P&Z CASE # SP 2019-029 P&Z DATE 8/13/2019 CC DATE _____ APPROVED/DENIED _____
ARCHITECTURAL REVIEW BOARD DATE _____ HPAB DATE _____ PARK BOARD DATE _____

Project Number: SP2019-029

SITE PLAN

THE JOUR SALON & SPA ADDITION

SITE PLAN

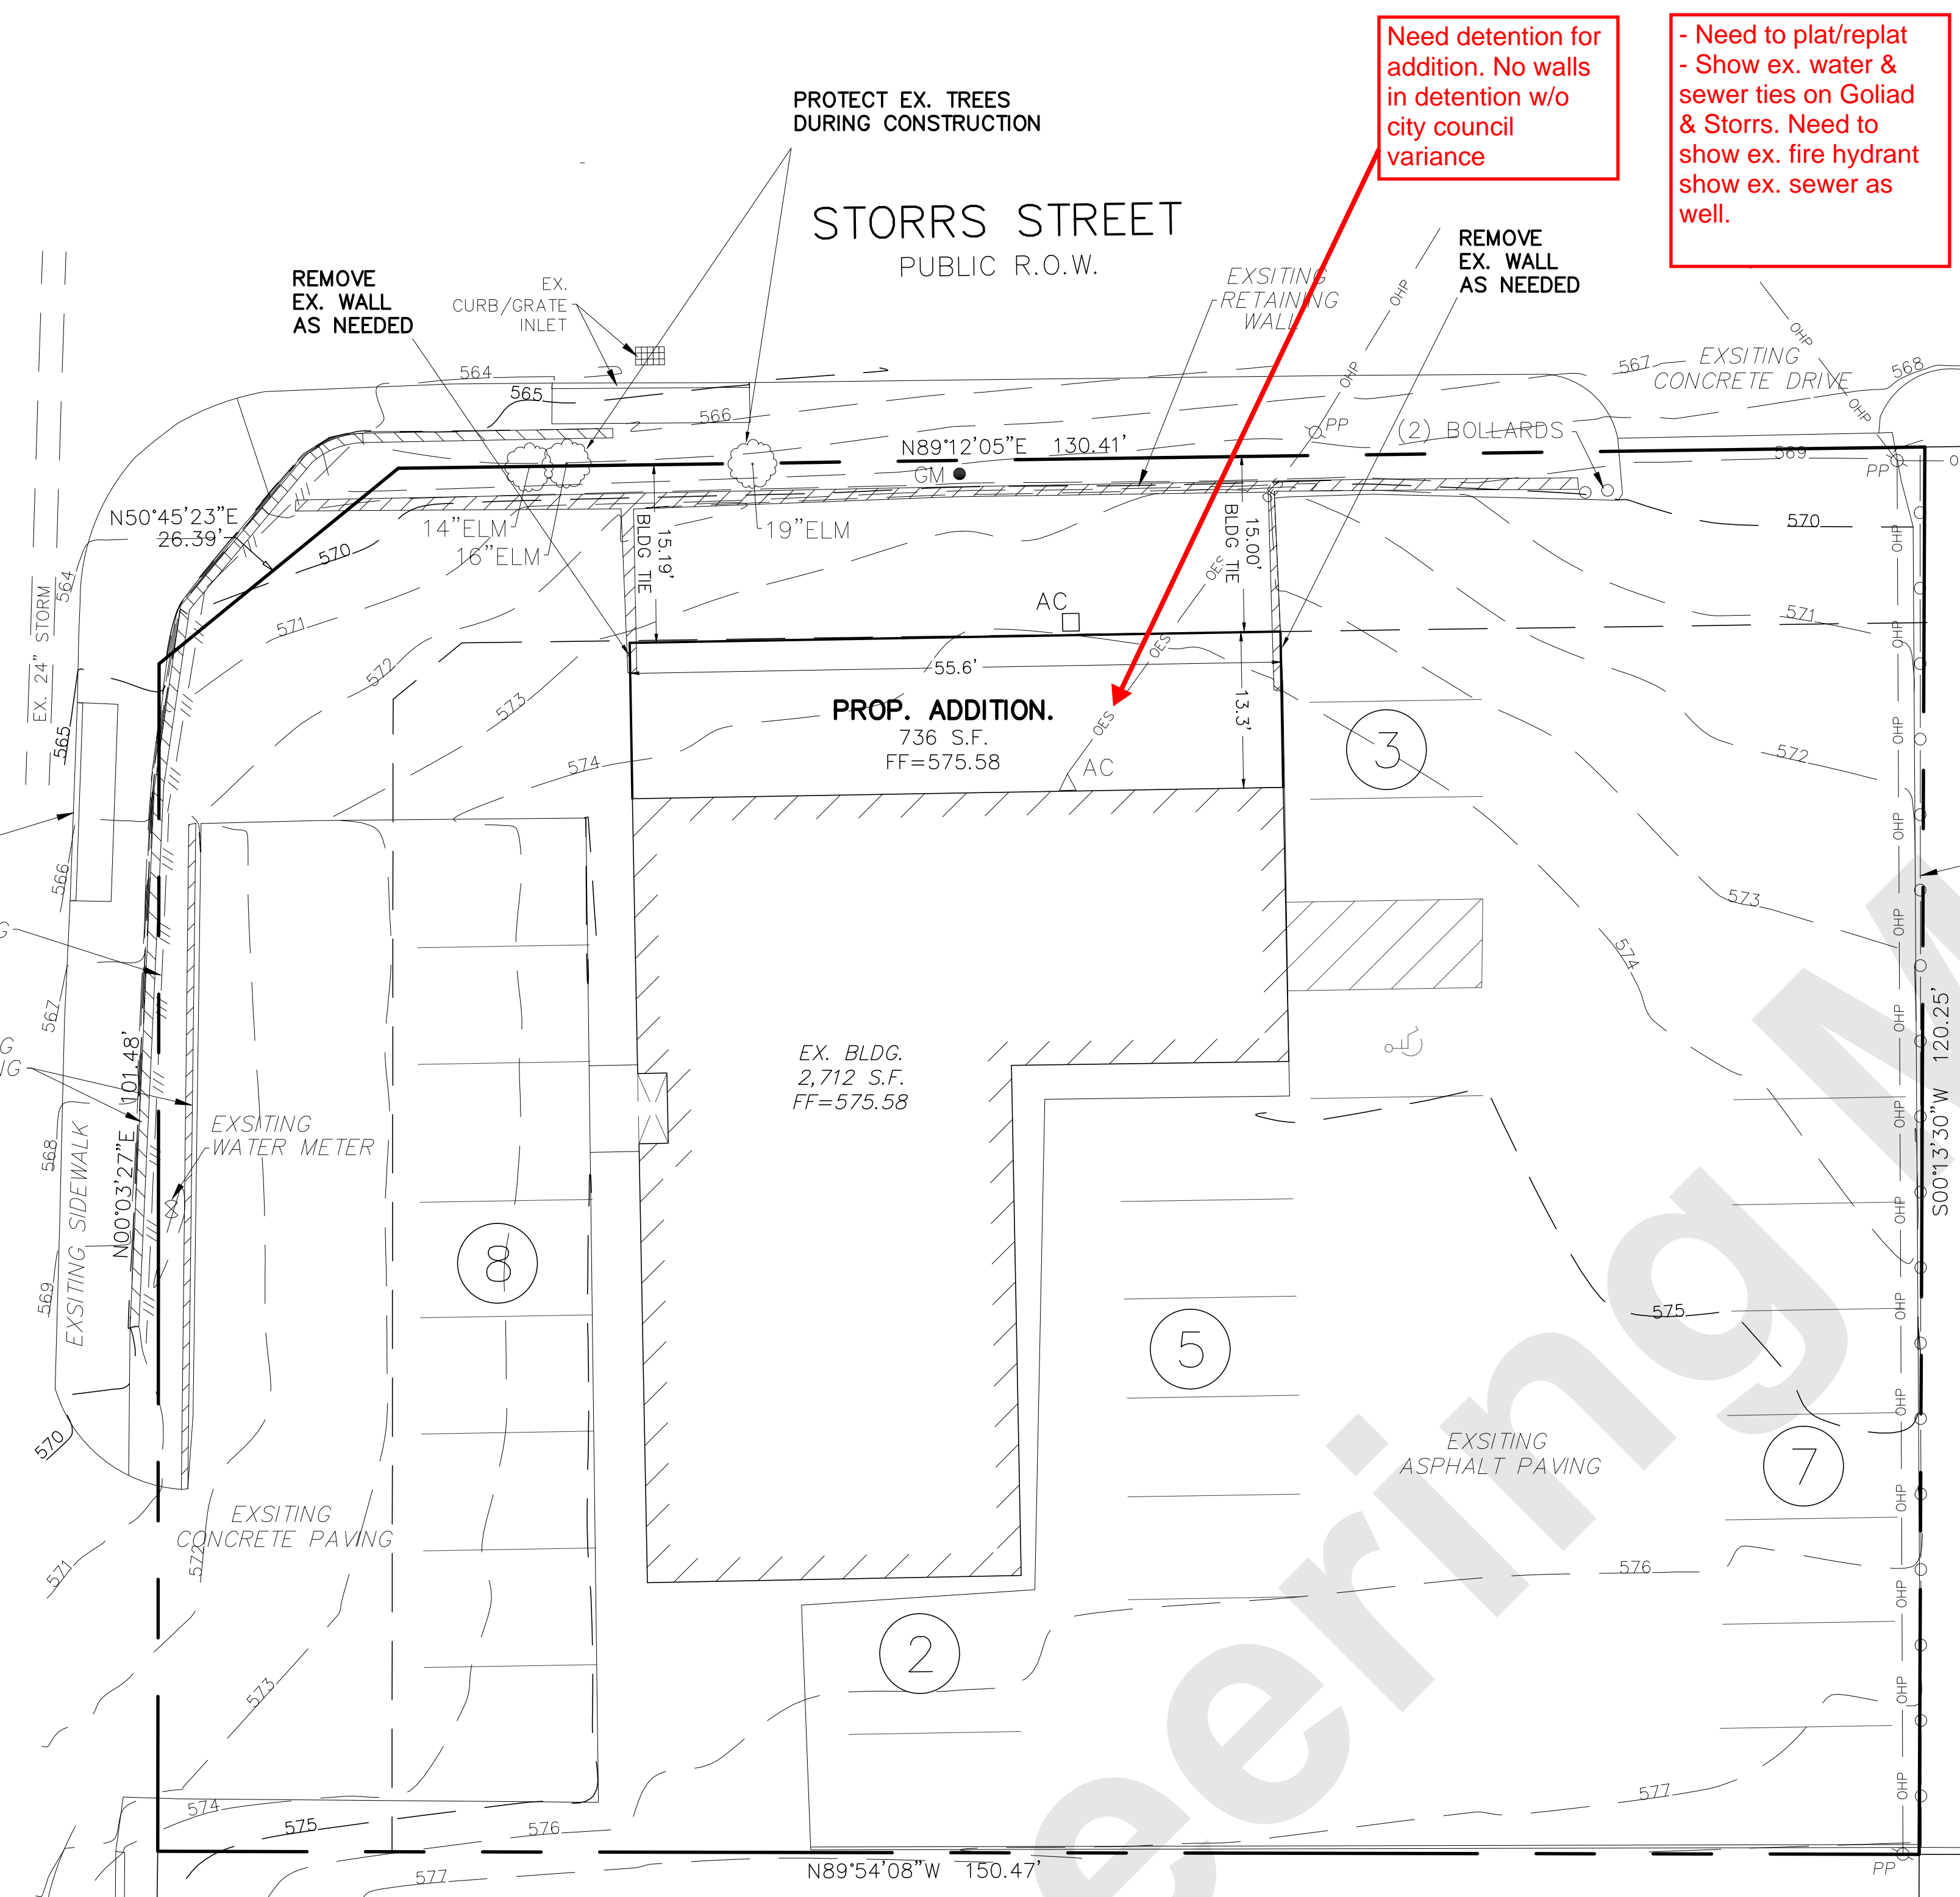
Need detention for addition. No walls in detention w/o city council variance

- Need to plat/replat - Show ex. water & sewer ties on Goliad & Storrs. Need to show ex. fire hydrant show ex. sewer as well.

SITE PLAN

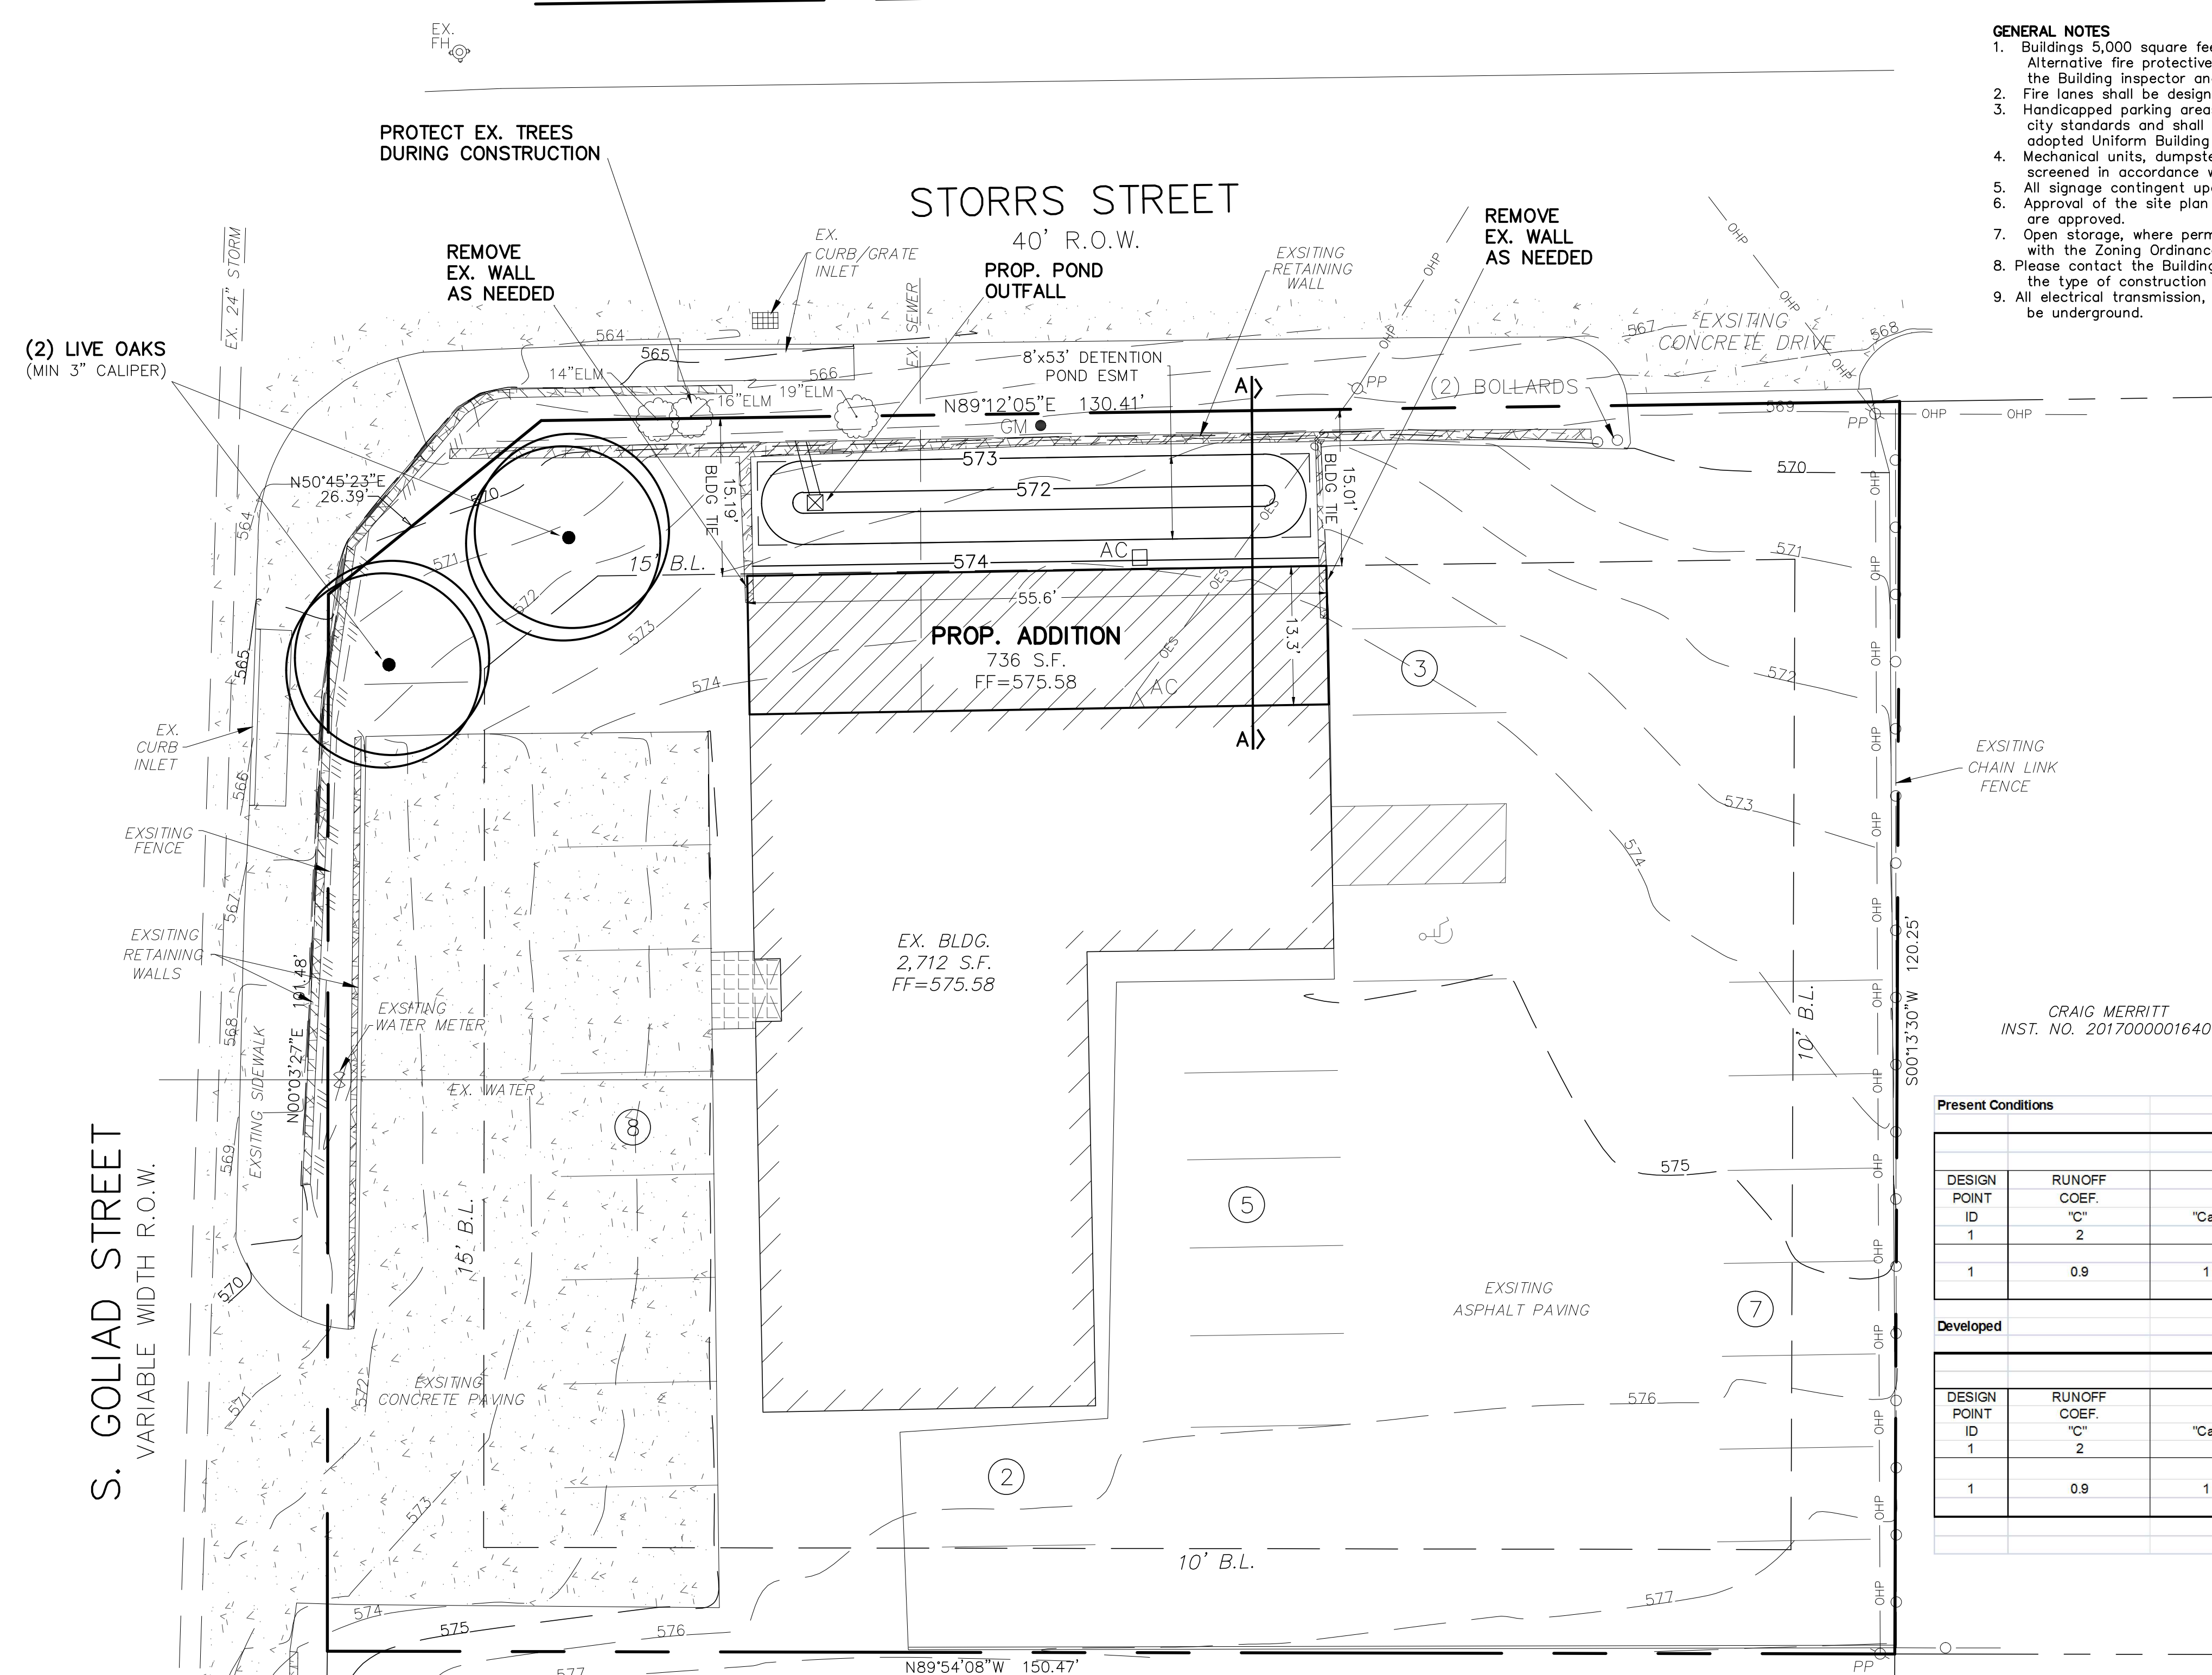
1. Requires approval by the Planning and Zoning Commission.						
2. Remove drainage calcs from site plan. This information is not to be on the site plan and is only reviewed/approved during the civil engineering submittal process.						
Police Department	David Gonzales	7/22/2019	7/29/2019	7/22/2019	COMMENTS	See comments
(7/22/2019 10:48 AM DG)						
Comments provided by Captain Ed Fowler - Rockwall Police Department.						
SP2019-029 501 South Goliad Street						
Considerations for New Construction Component:						
<ul style="list-style-type: none"> • Placing shrubs that provide area denial capability (e.g. thorns) and are natural to the area under windows on the left side (North) and window on the far left window on the front side (West) of the building. • Alarms: Glass break sensors on all windows, door alarms and alarm on safe room and safe if applicable. Interior motion sensors for alarm system. • Ground wash lighting placed along the exterior of the building for aesthetics and lighting on all sides of the building to eliminate shadows, hiding spots and to illuminate exterior windows (potential entry points). In addition, exterior lights placed on the eaves at the center of building could be moved to the ends of the building. This along with the ground wash lighting would provide appropriate lighting coverage. Lighting should comply with City of Rockwall Code. • Parking lot lighting should be considered if clients/employees will be working late. • Window Tint/Laminate • Tree and bush standards appear to be within specifications. • Install cameras on corners and interior of building along with all doors being equipped with alarms, the interior equipped with proximity alarms and glass break sensors on the windows. • Consider a panic alarm system for employees who may be working late and/or are alone at the business.
